STAFF REPORT

CASE NUMBER: P.D. 07-321 **L.U.C.B. MEETING:** August 9, 2007

DEVELOPMENT NAME: Central & Haynes Planned Development

Site Plan

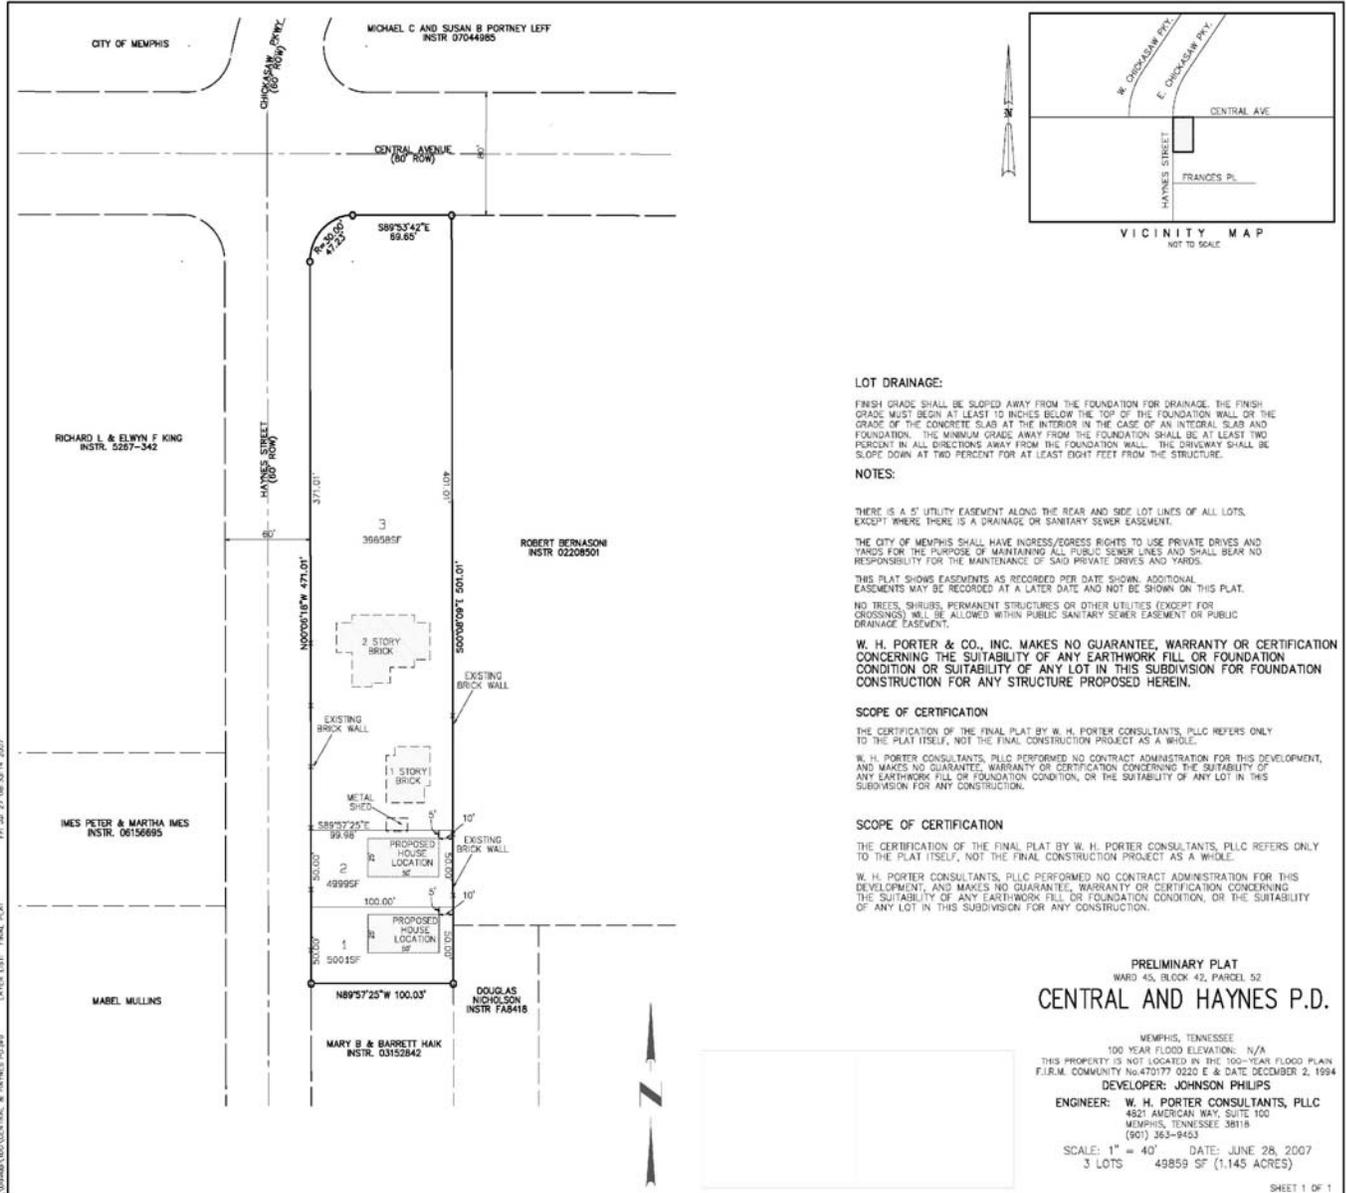
The biggest change associated with this request is the size of the proposed lots, and to a lesser extent a smaller lot width. The depth of the lots (measuring west to east) at 100 feet places a natural restriction on the ultimate lot size. In the R-S6 District the minimum lot size is 6,000 square feet. To meet this requirement, the frontage or width of each of these lots needs to be 60 feet. Unfortunately there is not 120 feet of frontage in the back yard of the existing lot without taking off part of the existing garage which is a significant structure. The other option available under current zoning is to restrict this re-development to one additional lot.

If this proposal were for two lots that not only front on Haynes Street but also offer a direct view into the lots from Haynes Street, then such a recommendation may be forthcoming. However, in this instance, the plan is for the existing brick wall to remain in tact, with the exception of cut outs for the drive ways. This will keep the existing character of this site in tact as it already incorporates the

Short of making these recommendations, the staff suggests that the developer/designer consider replacing the wood siding on the top 1/2 of the brick wall with brick. The existing wood has a worn appearance that does not project well on a public street frontage. Even new brick or A brick pattern would improve the aesthetics.

The developer/designer should also consider consolidating the two drives into one. This reduces the number of intrusions into the brick wall and the visibility from the street into the lots. The common lot line could run down the center of the entry drive or the drive could be set up as a common lot with an agreement for mutual ownership and maintenance.

- C. Lots 1 & 2
 - 1. Lot Size: – As depicted on the Outline Plan submitted with this application.
 - 2. Rear Yard Setback – Minimum of 10 Feet
- III. Access and Circulation:

- A. The applicant shall provide typical building elevations for the houses on the final plat.
- B. An elevation of the brick wall and the entry gate shall be included on the final plat. The brick wall may be modified to replace the wooden portion with brick.
- C. The fence surrounding the front yard of Lot 3 shall include wrought iron, brick, or stone, or combinations of these elements but in no event shall include wood or chain link. An elevation shall be included on the final plat.
